## REBUTTALS TO ARCO'S GROUNDWATER INJURY REPORTS

OCTOBER 1995

**REBUTTALS TO ARCO'S GROUNDWATER INJURY REPORT  
BY REMY HENNET AND STEVEN P. LARSON**

**PREPARED FOR  
STATE OF MONTANA  
NATURAL RESOURCE DAMAGE PROGRAM**

Figure 2: Location map showing the location of the Yellow Ditch (heavy black line, Newell, 1995) and the mapped streamside tailings (hatch pattern, Titan, 1995).

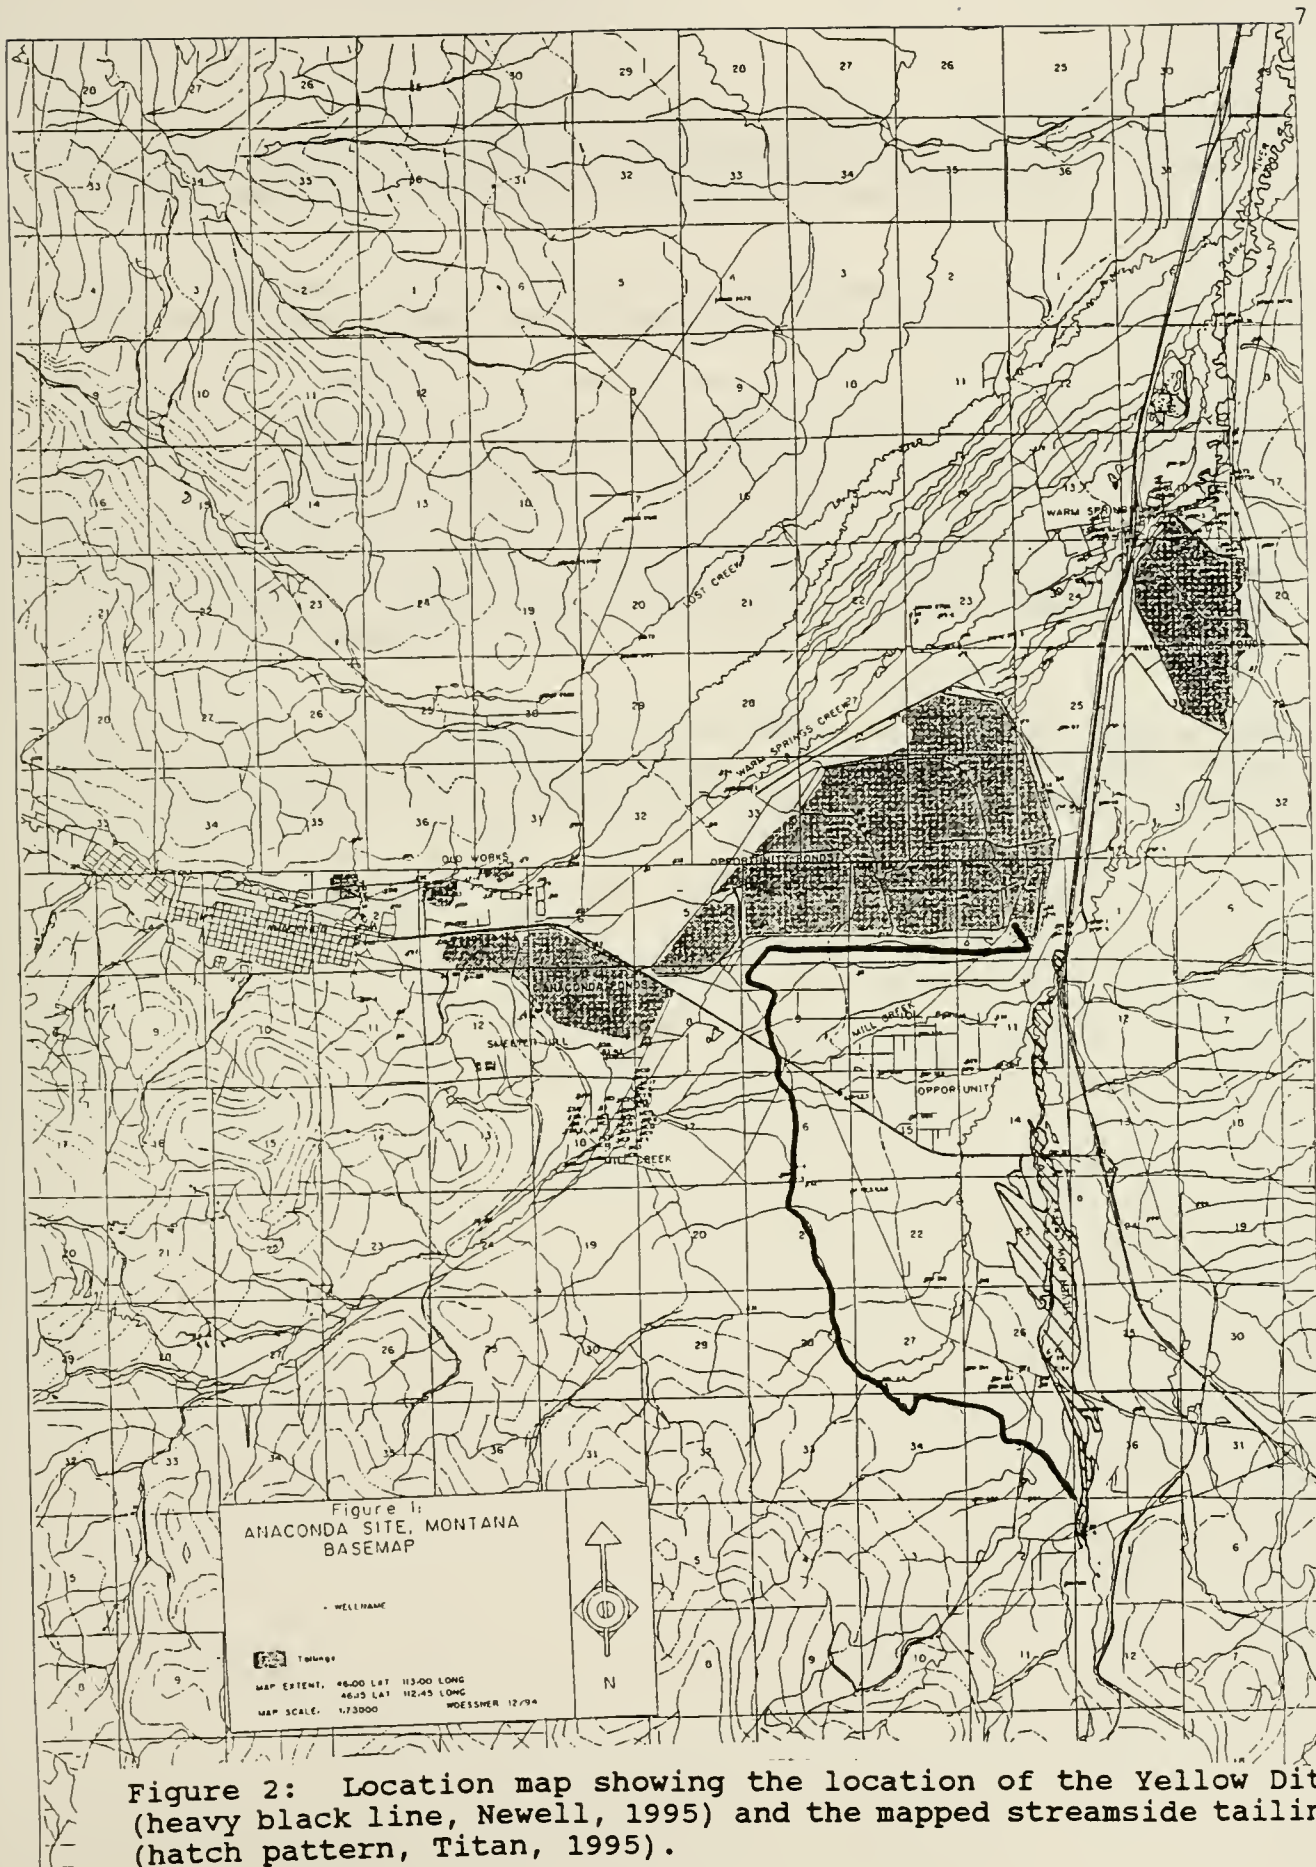
Also on page 32, Larson questions the mapping of hazardous materials in groundwater south of Anaconda and Opportunity Ponds.

Hazardous materials are present on the land surface south of the two principal tailings ponds at Anaconda. The source of these contaminants is directly related to tailings deposited by Silver Bow Creek and related irrigations ditches, the Yellow Ditch that supplied water to the large tailings pond area (Newell, 1995), air fall of particulate from the smelter operations, and failure of tailings pond berms and ditches that distributed tailing beyond the boundaries of these structures (Newell, 1995). Figure 2 presents a representation of the location of area associated with the Yellow Ditch and the mapped streamside tailings associated with Silver Bow Creek. Lands located between these features and adjacent to them are contaminated to varying degrees by tailings and air fall. Hazardous materials are released from the land surface and soils by infiltrating precipitation, as the water table contacts the hazardous materials and by the infiltration of ditch water and Silver Bow Creek water through contaminated soils. The streamside tailings have been characterized in Titan (1995). They have also generally assessed water quality impacts in the streamside tailings area. The regional groundwater study is beginning characterization of the Yellow Ditch deposits (Titan, 1995) (Woessner, 1995). Silver Bow Creek, the Yellow ditch during its operation, and related irrigation ditches are all losing water

to the groundwater system (Titan, 1995). Concentrations of cadmium, iron, and manganese exceeding drinking water standards occur at depths of 10 to 15 ft below the water table.
